SERVICE BULLETIN

Number: SB9523-20

Subject: Thumb Latch on Encore Hydro Walk-Behinds

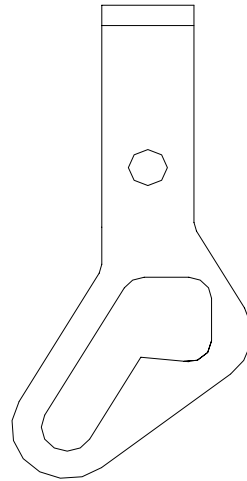
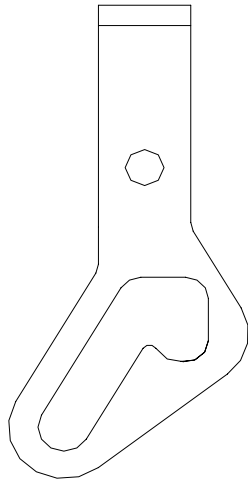
It may be possible that a few of the Hydro's may have been sent out with the old belt-drive thumb latch. Please check your upper handle assy to see that the right one has been installed. Refer to the example below. If you have the wrong latch, you will have difficulty setting neutral without going to reverse when going to neutral with the thumb latch.
